153-157 Walker Street Response to DPHI and NS Council Comments

1. Response to DPHI Comments

Response to DPHI Comments

Typical Façade Section

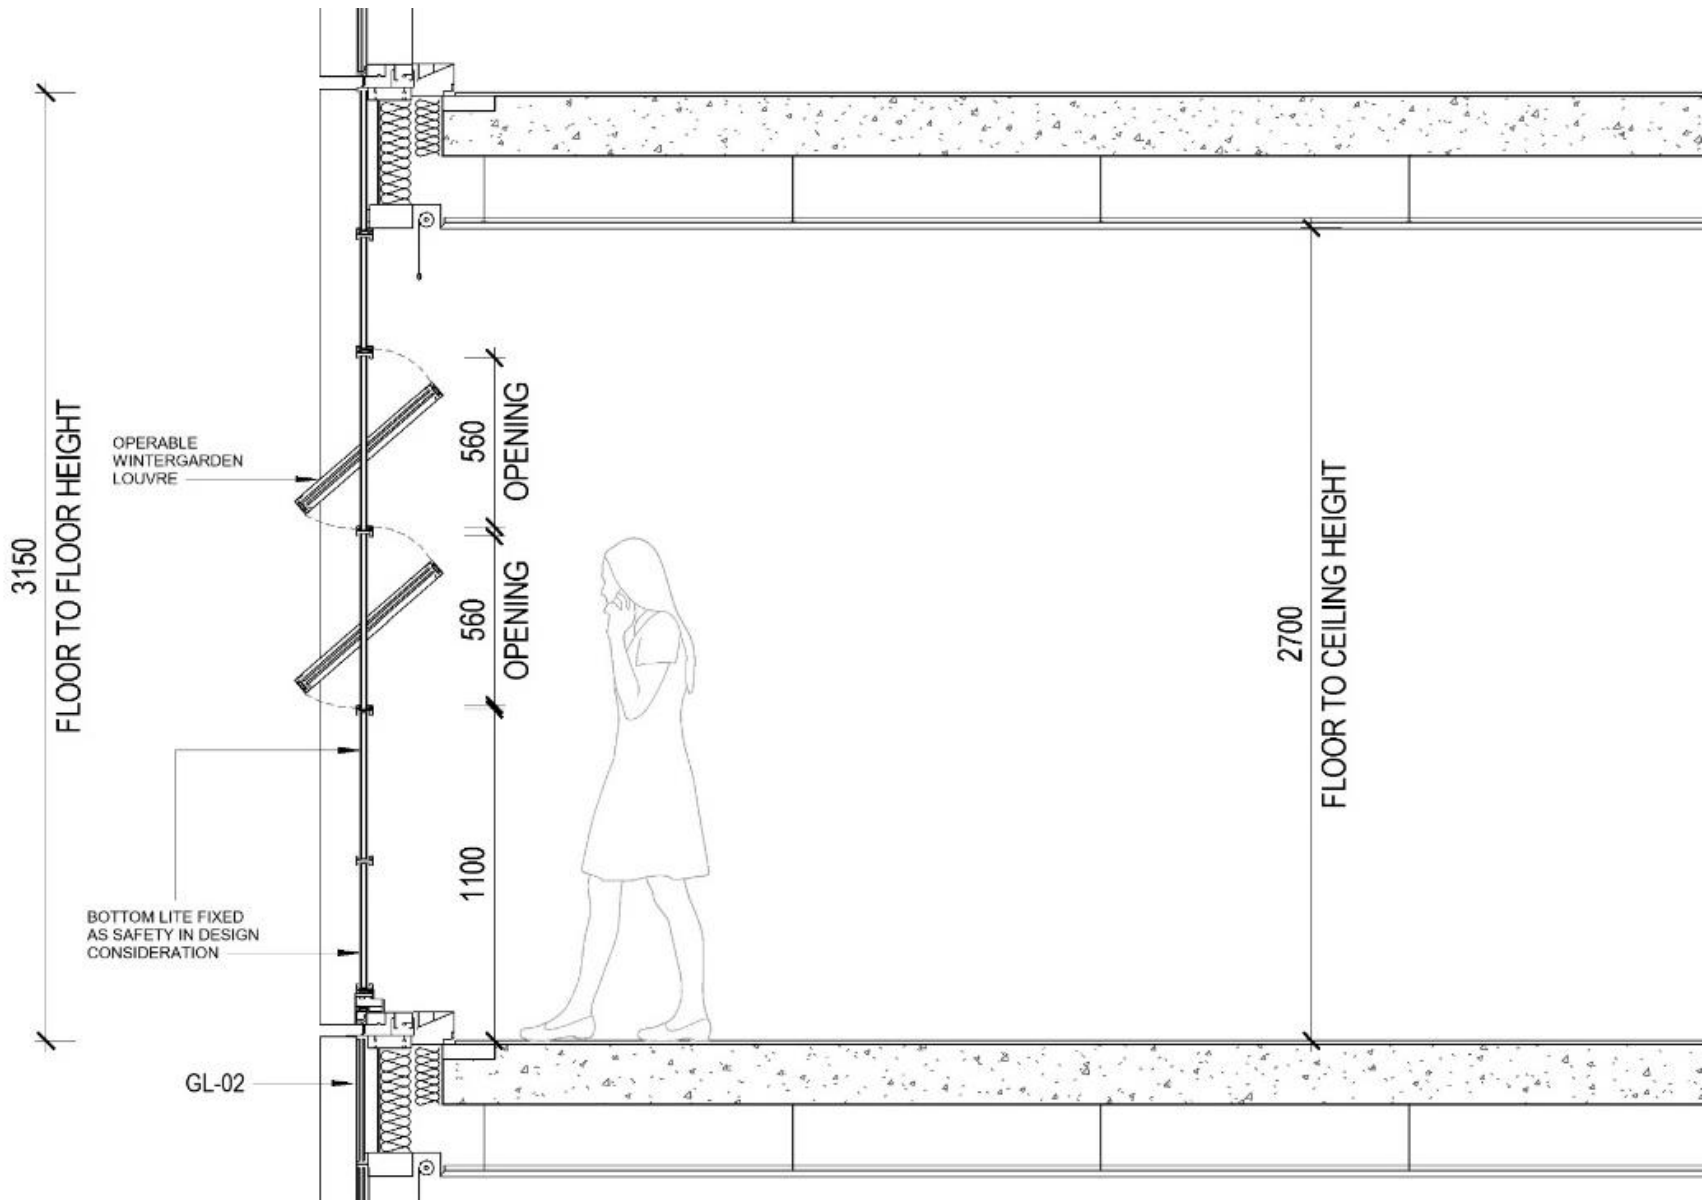
1. Given operable louvers are proposed, there is potential for these balconies to be fully enclosed and as such cannot provide cross-ventilation

The proposed winter gardens are designed to maintain cross-ventilation in accordance with ADG Part 4B-3. Operable louvres are provided along the winter garden façades, which are not fully air-tight, allowing continuous airflow between the external environment and internal living spaces.

These panels are not permanently fixed; residents can adjust them seasonally, ensuring the space is naturally ventilated. This allows for maximum occupant flexibility, allowing for enclosing of the balcony areas at times when wind and weather conditions are too severe to keep them open. According to RWDI wind engineers' advice (reference no. 2507337, dated 12/12/2025), fixing the louver in a fixed open condition would result in wind noise (whistling) during high wind events, which, due to site location and exposure, particularly to southerlies and easterlies, would have an adverse impact on occupant amenity.

The design of winter gardens has been carefully considered with this particular location in mind. By utilising a flexible façade design, these spaces, directly connected to the living areas, enable air to flow through the primary habitable spaces and provide ventilation equivalent to an open balcony, demonstrating that the winter gardens meet the intent and objectives of the ADG cross-ventilation requirements.

Section through Access Hatch

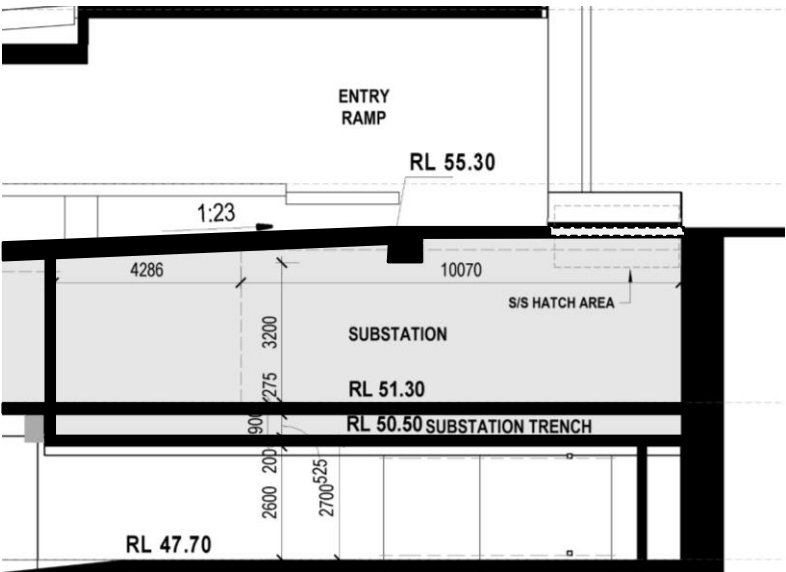
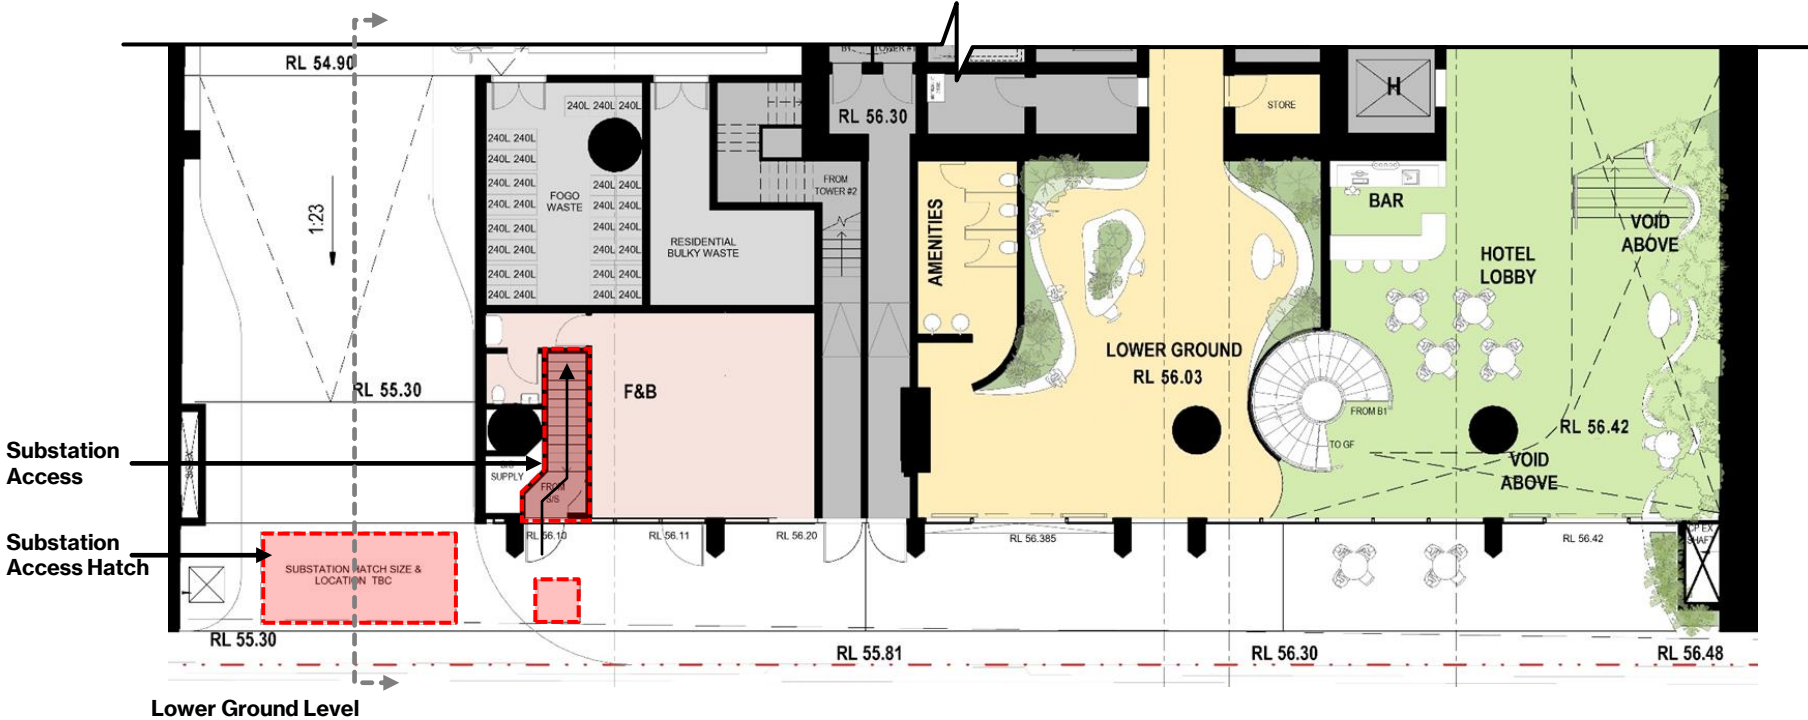
2. All access points to the substation need to be external to the building per Ausgrid Network Standard NS113 and details submitted with amended plans. All access points to the substation need to be external to the building per Ausgrid Network Standard NS113 and details submitted with amended plans.

The proposal provides a dedicated personnel access door and secondary service hatch on Little Walker Street. This arrangement complies with Ausgrid Network Standard NS113, which requires external, 24/7 access that does not pass through secure or internal areas. The configuration is consistent with Clause 8.2.5.3 (Option C), permitting a street-level hatch with ladder and equipment access via a vertical shaft.

Accordingly, the substation can be fully serviced from the street without reliance on internal circulation routes, loading docks, or building-controlled spaces.

21 March – 9am

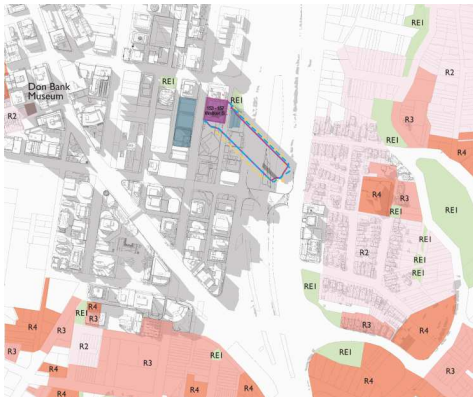
4. Consent has been granted for the proposed residential building at 146 Arthur Street to the east under SSD-61000021. Please modify the sun view diagrams and shadow diagrams to include this building.

The images to the right depict a shadow analysis Study done for the 21st March from 9AM to 3PM. The study considers the existing North Sydney Context plus approved DAs as 110 Walker Street, 100 Walker Street and 146 Arthur Street.

21 June – 9am

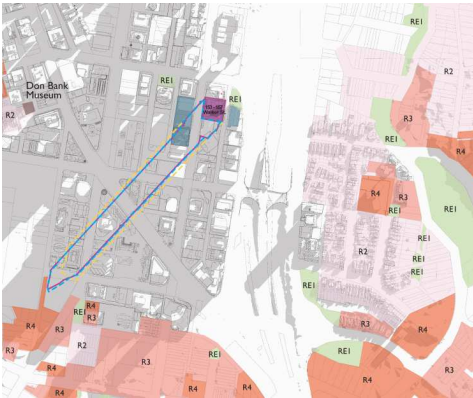
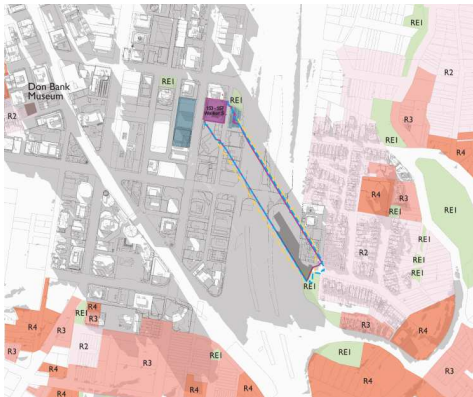
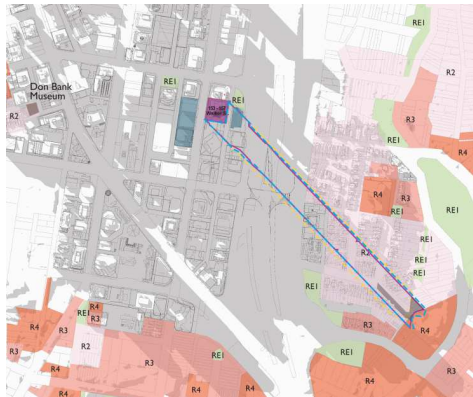
4. Consent has been granted for the proposed residential building at 146 Arthur Street to the east under SSD-61000021. Please modify the sun view diagrams and shadow diagrams to include this building.

The images to the right depict a shadow analysis Study done for the 21st June from 9AM to 3PM. The study considers the existing North Sydney Context plus approved DAs as 110 Walker Street, 100 Walker Street and 146 Arthur Street.

21 June – 9am

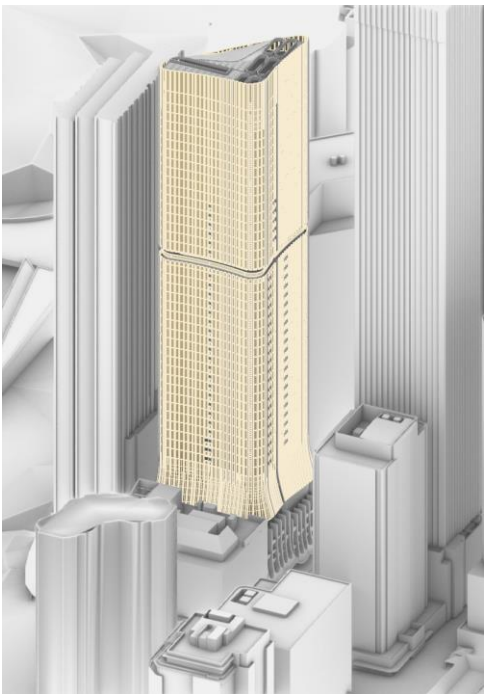
4. Consent has been granted for the proposed residential building at 146 Arthur Street to the east under SSD-61000021. Please modify the sun view diagrams and shadow diagrams to include this building.

The images to the right depict a Views from Sun Analysis done for for the lodged design that considers approved DAs for North Sydney CBD including the recently approved 146 Arthur Street.

As it can be seen the impact of the approved development at 146 Arthur Street has a minimal impact on solar amenity, predominantly affecting the proposed building in the period up to 9AM. Only a small southeastern corner is affected at 9AM, which gets solar access past 11AM still complying with the 2 hour minimal requirement.

Western Elevation - Without 146 Arthur Street

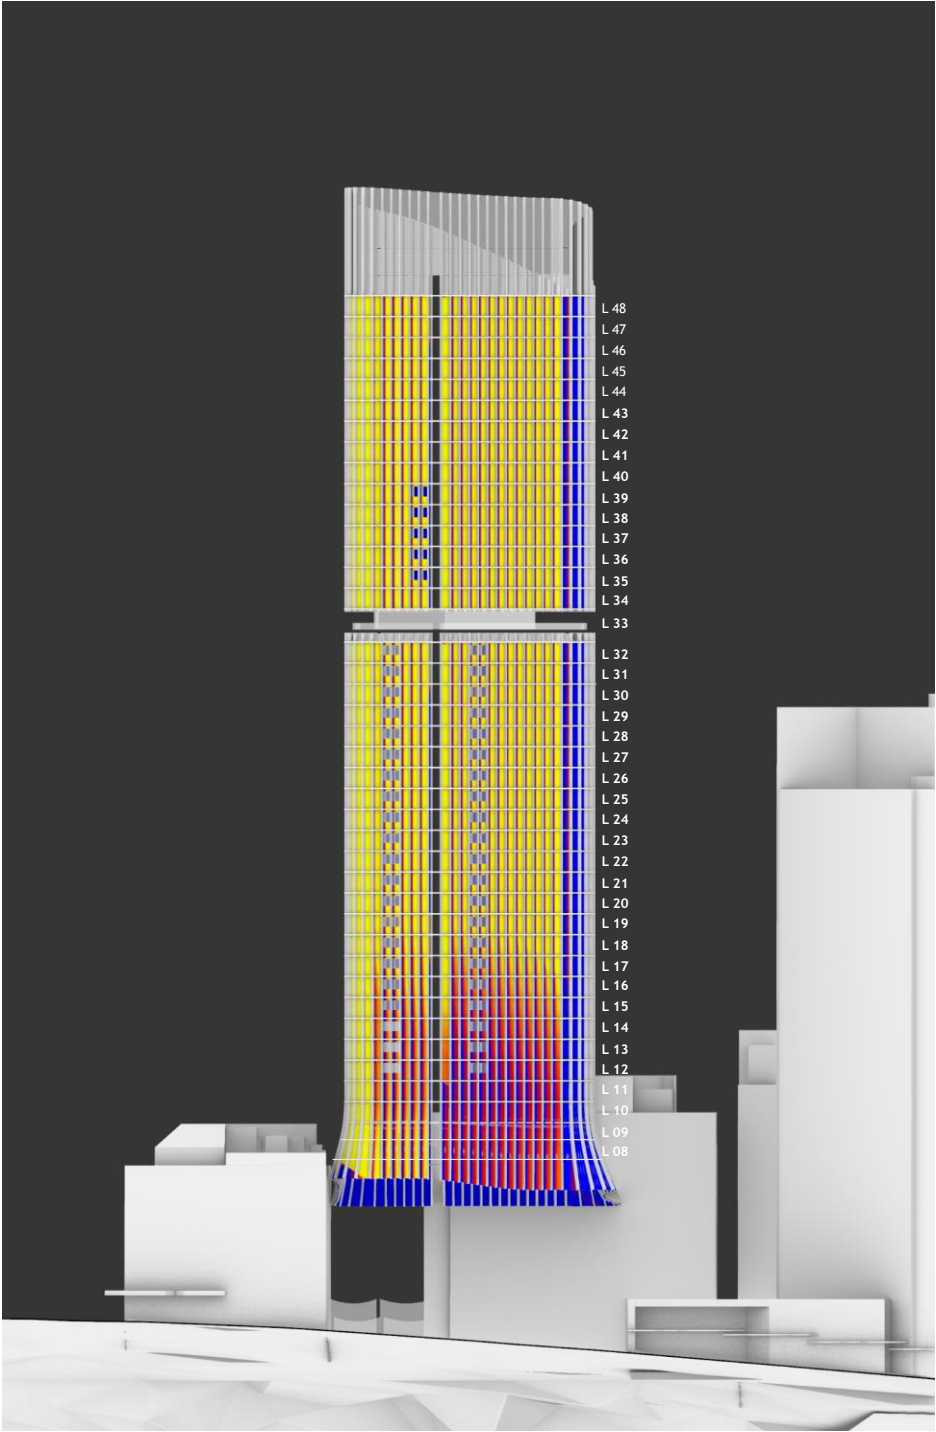
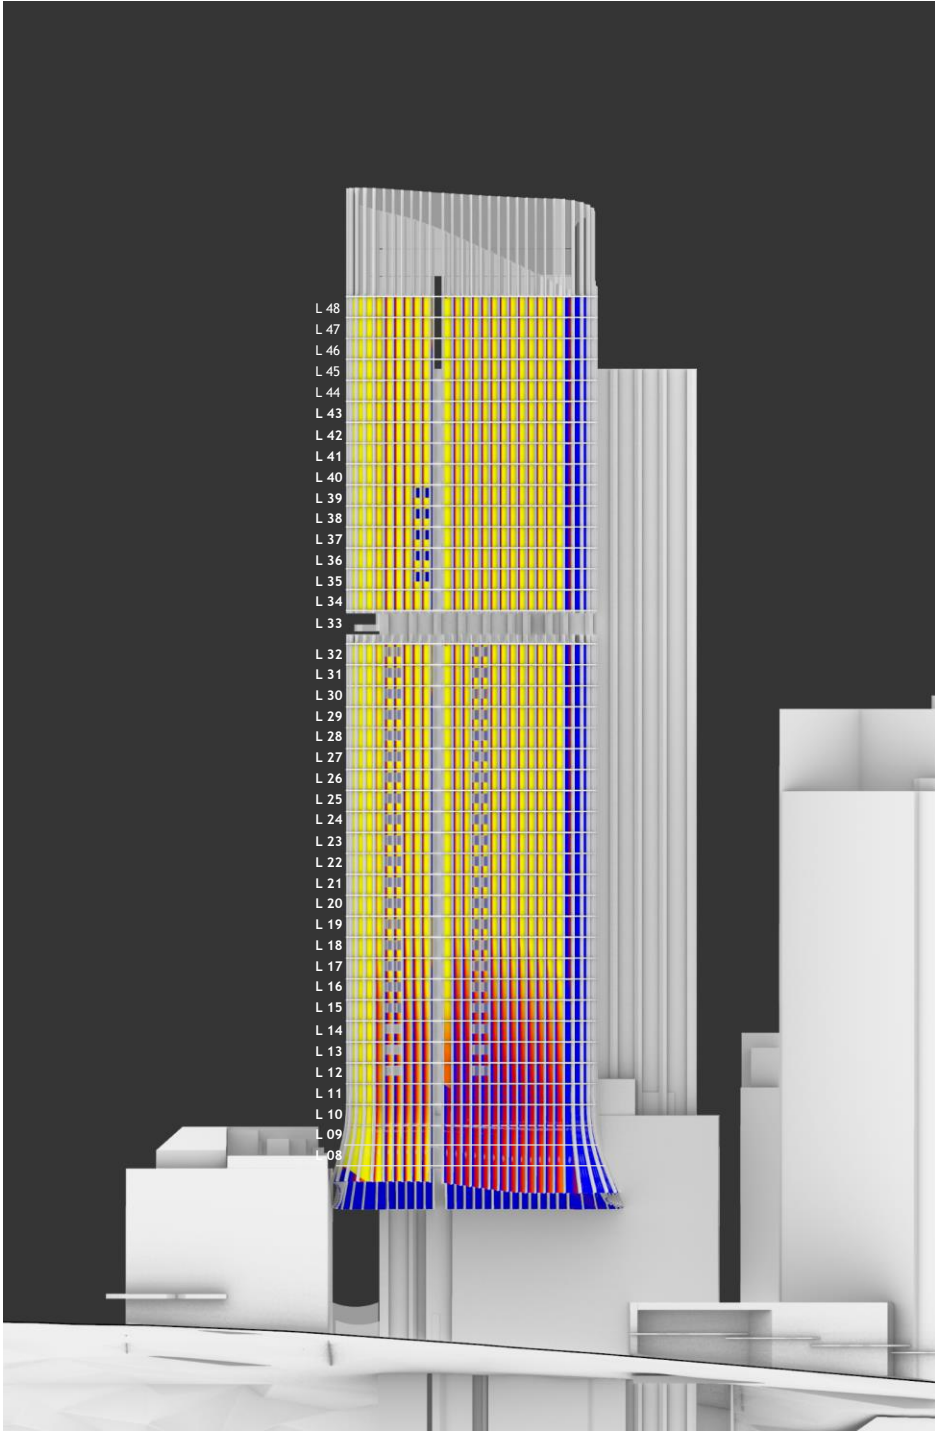
8. Further information is required to confirm the level of solar access to the dwellings of the proposal. Please provide hourly elevational solar diagrams and an accompanying information table in order to demonstrate where solar access falls within the building and its duration.

The images to the right illustrate an ADG Solar Access Analysis for the western elevation of the lodged design at 153-157 Walker Street. The ADG requires that a minimum of 70% of apartments receive at least two hours of direct sunlight on 21st June.

The analysis confirms that the 146 Arthur Street has no impact on the proposed design's solar access performance. The vast majority of apartments are oriented westward and continue to meet the ADG requirements. The proposed development achieves 72% solar access compliance.

Lastly, to mention that 146 Arthur Street massing has no impact whatsoever on the Western façade of the proposed design.
